# Wisconsin Department of Transportation

**Proposal #07: 1060-43-82  
East-West Freeway  
Elm Grove Rd Bridge over IH 94  
IH 94  
Waukesha County**

This is Addendum No. 02, which provides for the following:

**ADDENDUM NO. 02**

Addendum No. 01  
 ID 1060-43-82  
 Revised Sheet 57  
 May 31, 2016

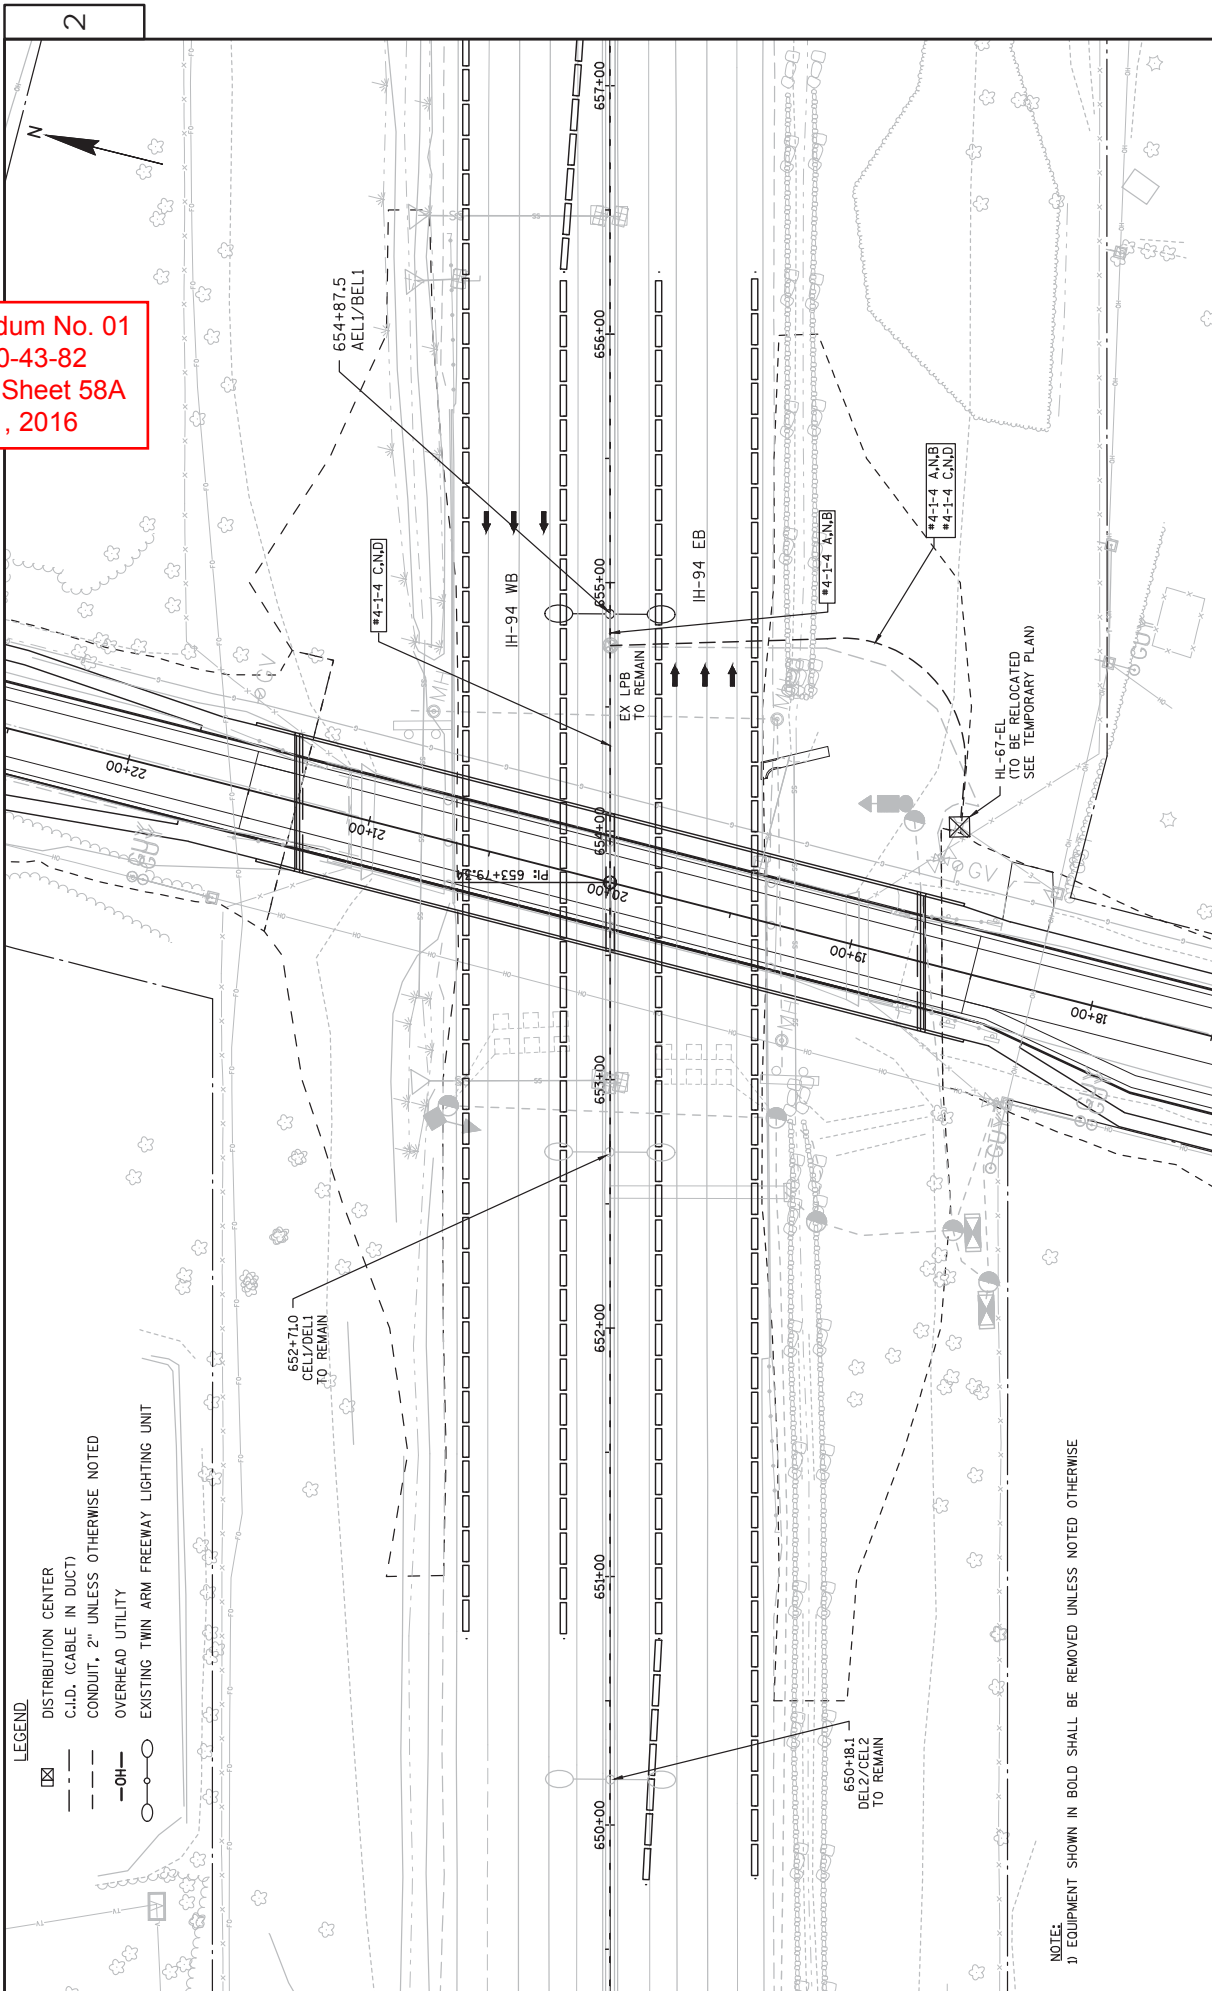
Revised Plan Sheets	
Plan Sheet	Plan Sheet Title (brief description of changes to sheet)
57	Project Overview – Lighting Plan (revised the note to reflect that the distribution center will be relocated)
59	Temporary Lighting Plan (revised to include the additional temporary lighting work required)
60	Lighting Plan (revised to include the additional lighting work required)
109	Miscellaneous Quantities (revised to include corrected quantity for Item 611.3004)
123	Miscellaneous Quantities (revised to include the additional lighting items and quantities)

Addendum No. 01  
 ID 1060-43-82  
 Added Sheet 58A  
 May 31, 2016

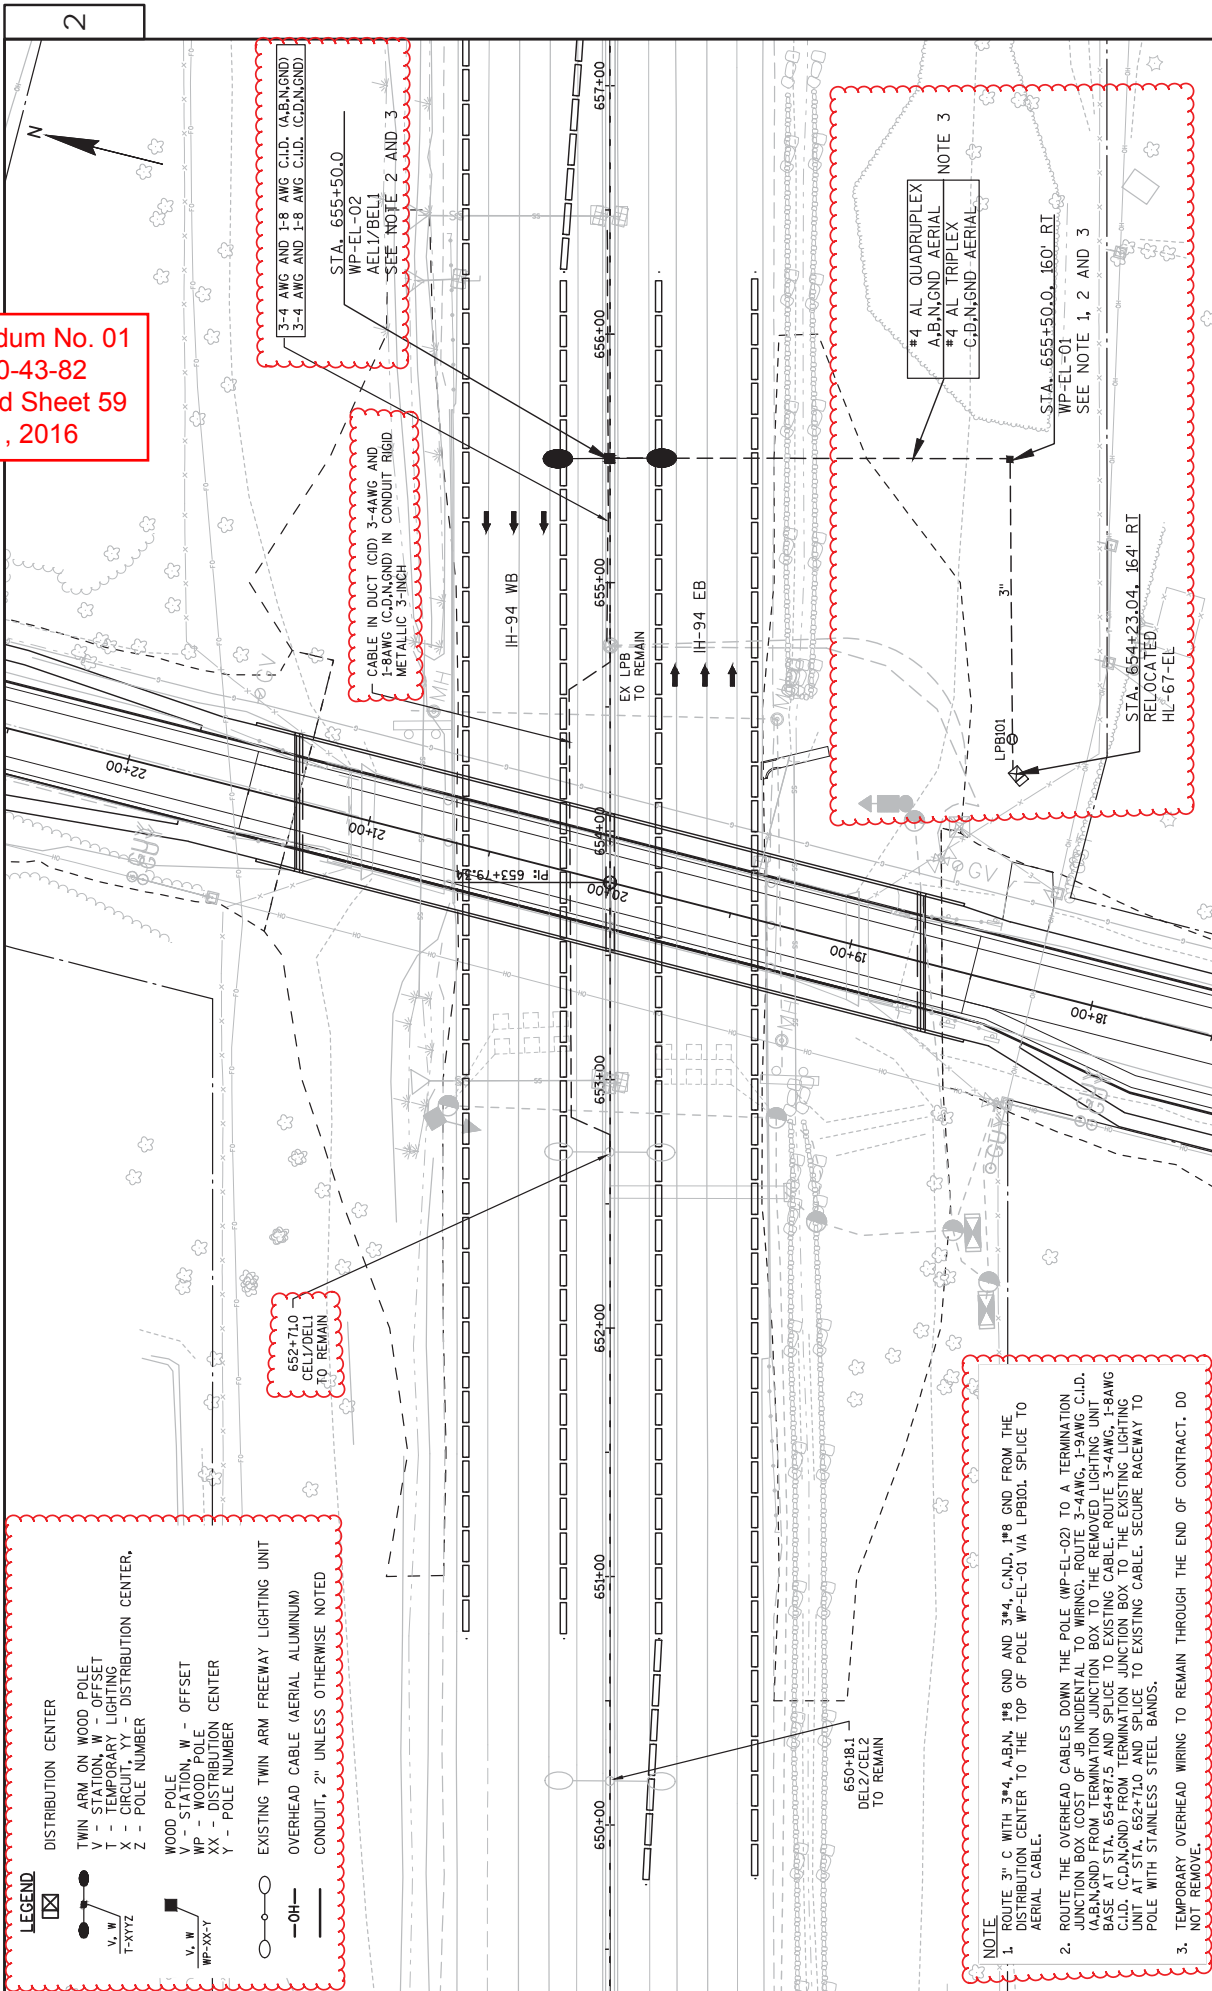
Added Plan Sheets	
Plan Sheet	Plan Sheet Title (brief description of why sheet was added)
58A	Lighting Removal Plan (added to reflect the existing lighting that has to be relocated due to project conflicts)
123A	Miscellaneous Quantities (added to include the additional lighting items and quantities)

NOTE:  
 1) EQUIPMENT SHOWN IN BOLD SHALL BE REMOVED UNLESS NOTED OTHERWISE
